Matter	Consideration/Description
Project Area and Disturbance Area	<p>Clarify the project area and the disturbance area for the proposed project, including both the TGO and SAR mines including:</p> <ul style="list-style-type: none"> - total hectares in the project area (breakdown hectares in the 'TGO Mine Site' and hectares in the 'SAR Mine Site'); - total hectares for disturbance in the project area (breakdown hectares impacted in the 'TGO Mine Site' and hectares impacted by the 'SAR Mine Site'); - breakdown of hectares for impacts (roads, voids, emplacement, other, across the disturbance area within the project area (TGO and SAR mine sites); and - total approved footprint of RSF2, noting discrepancy between the MOD 5 approved area of 64.3 ha, and Table 2.2 and 7.4 of EIS Volume 2 - Appendix 13 - RSF2 Design Report – RSF2 catchment area, giving footprint area of 57 ha (28.5 ha for each cell).

Disturbance Area Specialist Study Clarifications	<p>Inconsistencies identified throughout the EIS and technical studies include:</p> <p>Land and Soil Capability</p> <ul style="list-style-type: none"> - Does the Land and Soil Capability Assessment consider that the road disturbance is 81 ha o

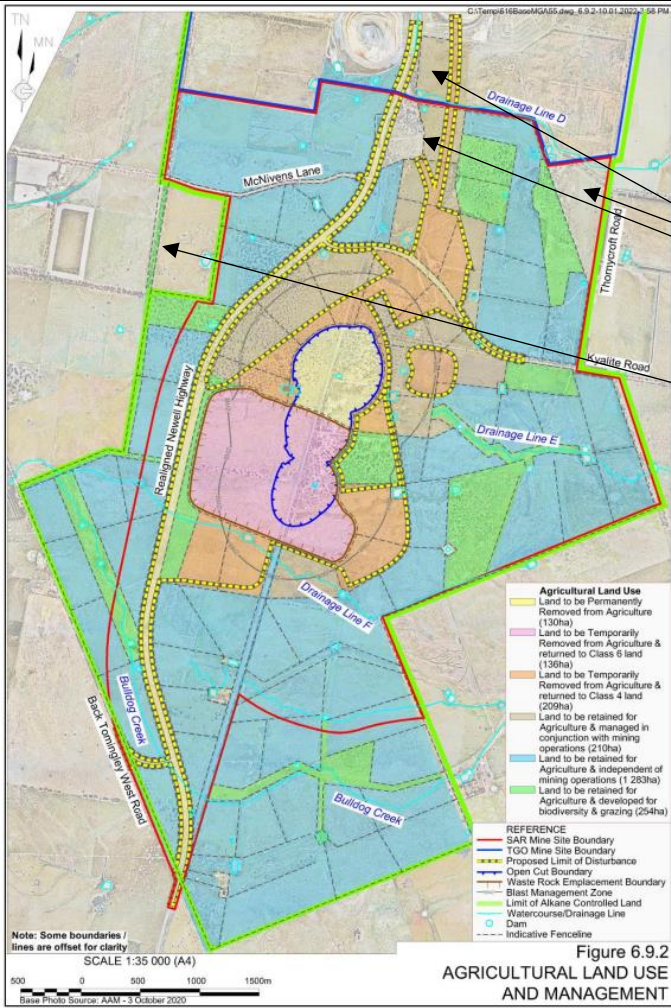
Matter	Consideration/Description
	Chromosol Soil Mapping Unit are Class 4 soils (section 6.8.2.5 of the EIS) and only 217 would be impacted by the project, where is the additional 100 ha of Class 4 soils?
Figures	<ul style="list-style-type: none"> - Provide a figure in JPEG or PNG format that includes the total project area (known as the TGO Mine Site and the SAR Mine Site in the EIS), the total disturbance area, and key infrastructure overlaid. Minimise the use of boxed labels on the figures and use the legends instead to clearly show the above requested items. - Provide Figures 1.1, 3.1.1, 3.1.2, 3.1.3 of the EIS in JPEG or PNG. - Provide Figure A Staged Vegetation Clearing of letter dated 22 July in JPEG or PNG.
Construction and Operation Staff	Provide breakdown of FTE construction and operation staff.
Clarification of Figure 6.9.2 of the EIS	 <p>Are these areas considered in the 2,222 ha?</p> <p>Is this area outside of the project area included in the land to be retained for agriculture (254 ha)?</p> <p>Figure 6.9.2 AGRICULTURAL LAND USE AND MANAGEMENT</p>

Disturbance Area in the TGO Mine Site	<p>What area was assessed in the TGO Mine Site? The Figures for this area vary between specialist area assessments:</p> <ul style="list-style-type: none"> - Figure 6.10.2 of the EIS:

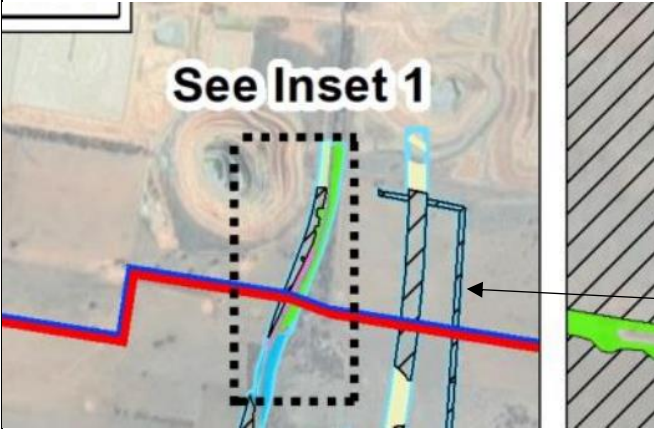
Matter	Consideration/Description
	<div data-bbox="435 241 1084 667">  <p data-bbox="602 296 857 352">See Inset 1</p> <p data-bbox="1105 478 1398 625">What is this area? Is this included in the disturbance area for the project?</p> </div> <p data-bbox="496 695 829 730">- Figure 6.11.1 of the EIS:</p> <div data-bbox="448 726 1084 1173">  </div>
